**Amendments to the Drawings**

FIG. 1

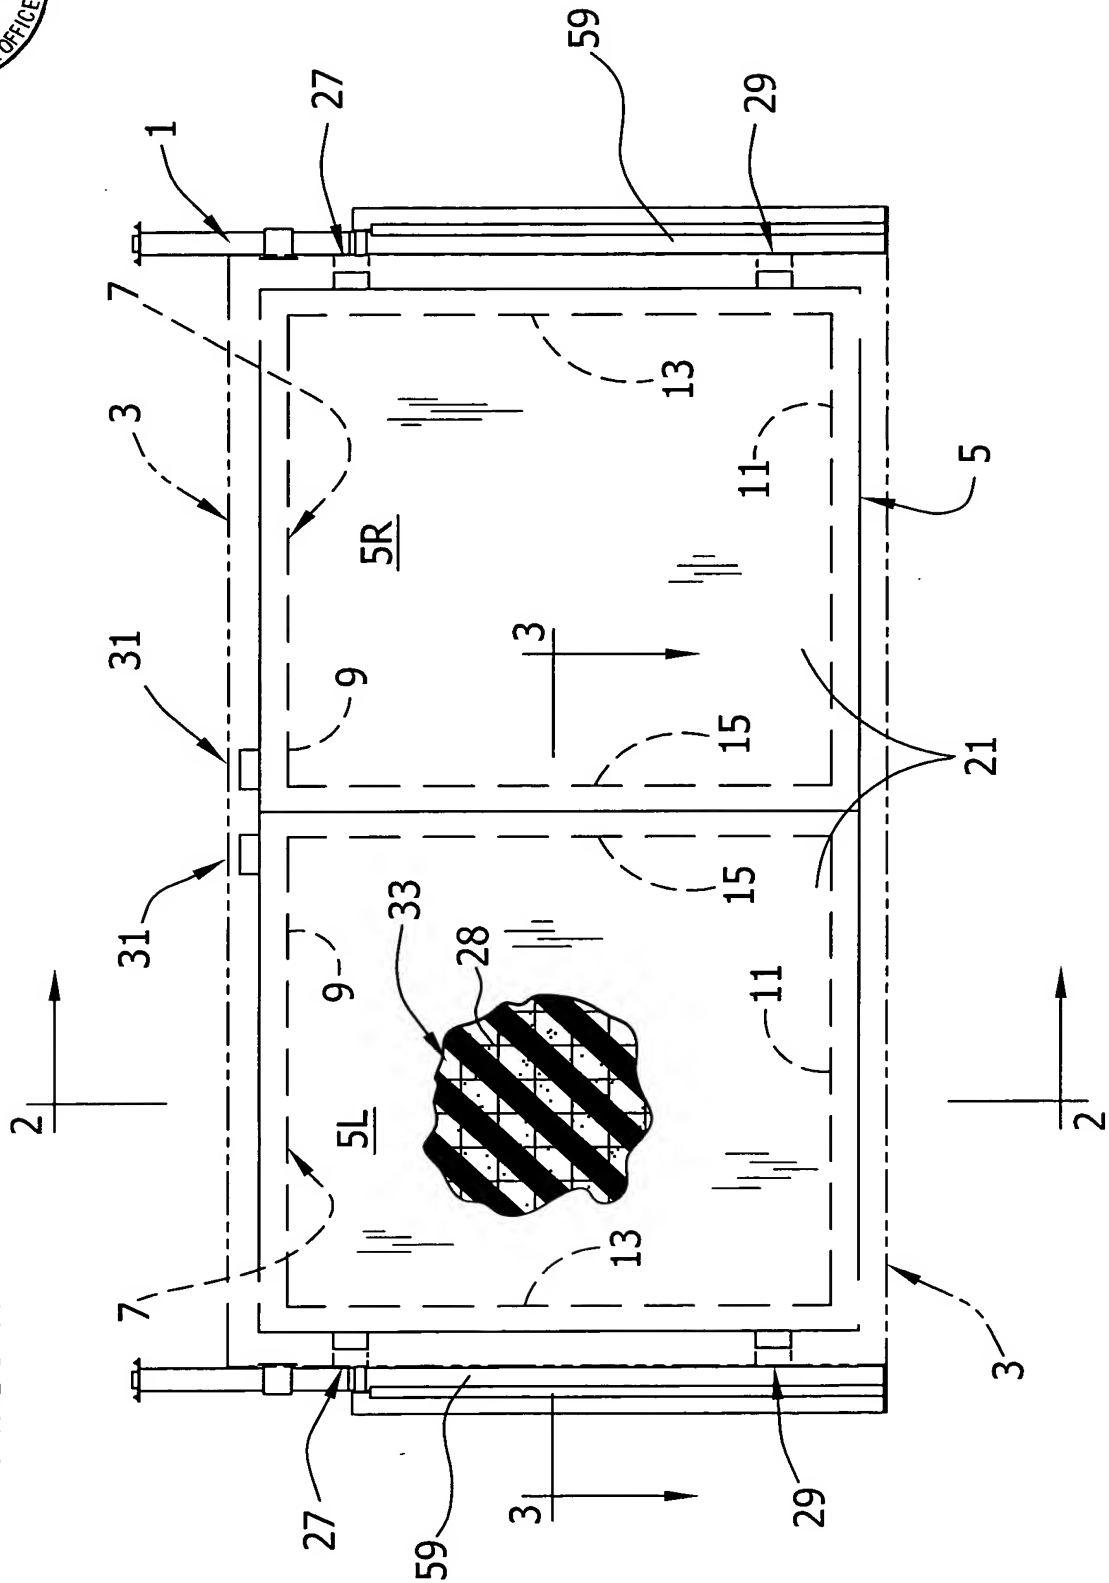
Please replace drawing sheets 1 and 2 with the attached replacement drawing sheets 1 and 2, which include amendments to Figs. 1 and 2. Fig. 1 has been amended to show an embodiment of the claimed columns (59) and an embodiment of the claimed wire screen (28, broadly a mechanical coupling device). Fig. 2 has been amended to show an embodiment of the claimed rebar-type elements (26). Support for the columns can be found in the specification on page 3, lines 11-19. Support for the mechanical coupling devices, including the wire screen and rebar-type elements, can be found on page 6, lines 3-6.
